APPLICATION NO.	FILING DATE	FIRST NAMED INVENTOR	ATTORNEY DOCKET NO.	CONFIRMATION NO.
10/807,932	03/23/2004	Qingqiao Wei	200314202-1	5174

<b>Office Action Summary</b>	<b>Application No.</b> 10/807,932	<b>Applicant(s)</b> WEI, QINGQIAO	
	<b>Examiner</b> DENNIS M. WHITE	<b>Art Unit</b> 1797

## DETAILED ACTION

**FIG. 12**

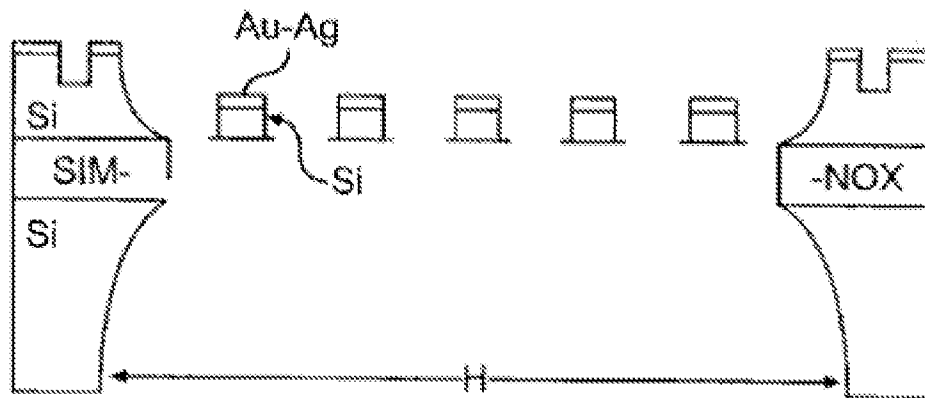
b) Kendall teaches the thin membranes may be heated and cooled in incredibly short times (Figure 12: "H"). Kendall therefore teaches an integral heater disposed proximate to the field-effect transistor to heat the field-effect transistor to an elevated temperature relative to the ambient temperature.

c) integral thermal insulation SIM-NOX disposed to maintain the field-effect transistor at the elevated temperature.

Regarding claim 2, Kendall teach the functionalized semiconductor nanowire comprises silicon (Figure 12)

Regarding claim 17-18, Kendall teaches wherein the integral heater is disposed between the substrate Si and the insulator SIMNOX (Figure 12: H)

Regarding claim 21, Kendall teaches wherein a portion of the substrate is removed to form an opening under the field-effect transistor (FET), the opening being at least partially aligned with the field-effect transistor (Figure 12)

Regarding claims 22-23, Kendall teaches the MOSFET (“field-effect transistor”) comprises a SIMNOX layer (broadly interpreted reads on “substrate” “includes a gate electrically insulated from the substrate”) (Figure 12: Si) which is fully capable of serving as a gate for the field-effect transistor.

Regarding claim 24, Kendall teach the gold-silver layer (“conductive catalyst”) on silicon (“functionalized semiconductor nano-wire”) is insulated from the substrate by SIMNOX layer which is fully capable of providing a gate for the field-effect transistor (Fig. 12).
